Email Memorandum	
To:	Glide Rural Fire Protection District Attn: Beth Werner	Email :	glidefire@glidefire.org
From:	Matt Keller, PE, CSI	Subject:	Shear Wall Repair Plan
Date:	19 May 2022	Project #:	21855.12

FIGURE 1

1 FOUNDATION PLAN
 S1.0 SCALE: 1/8" = 1'-0"

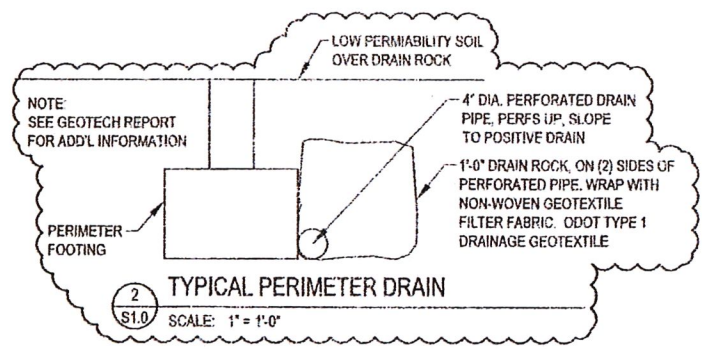
HIGHLIGHTED WALLS TO BE REPAIRED PER FIGURE 2

The repair plan shows the locations, as outlined by Glide Rural Fire Protection District, that require the repair and what nailing pattern is required for the repaired sections. Additional 2x blocking will be required to be installed at the edge of the existing panel edge, approximately 24" above the finished floor.

SHEARWALL REPAIR DETAIL

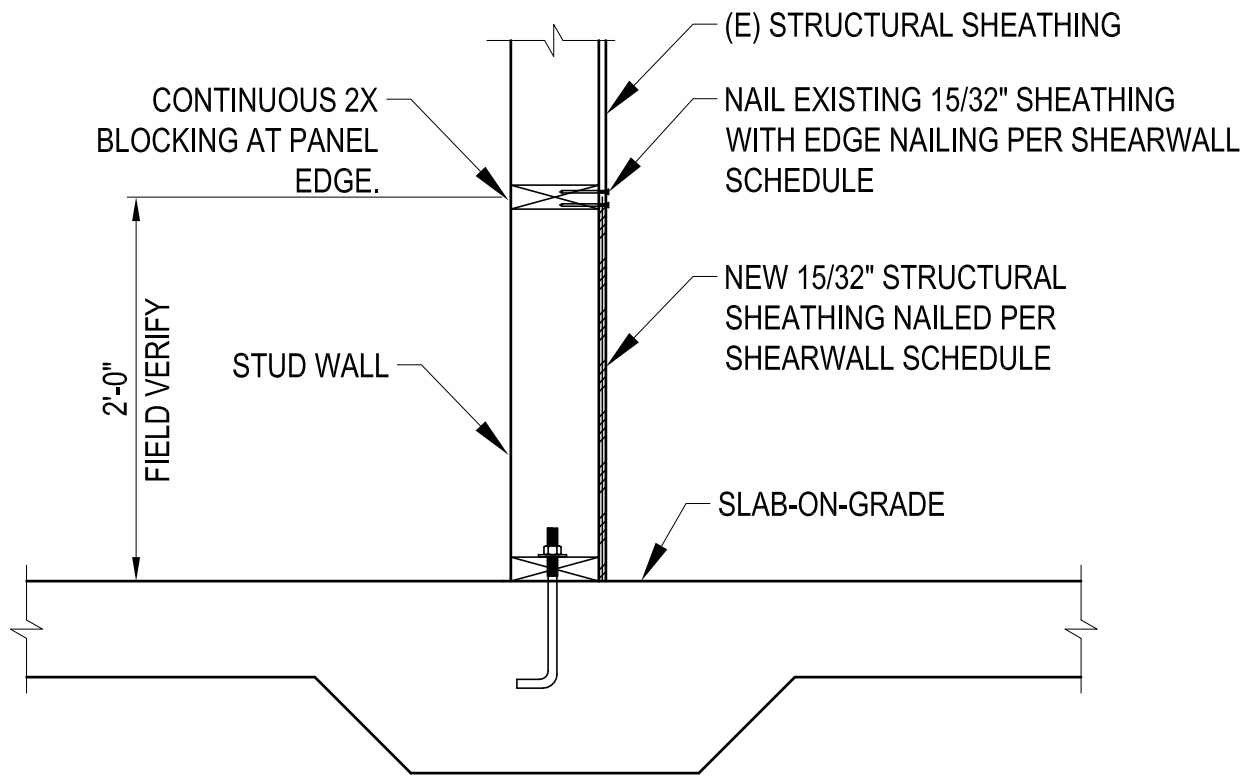
In response to your question regarding repair of damaged shear walls that have had the existing structural sheathing removed along the bottom 24 inches of the wall, Pinnacle Engineering, Inc. (PEI) has prepared a repair plan.
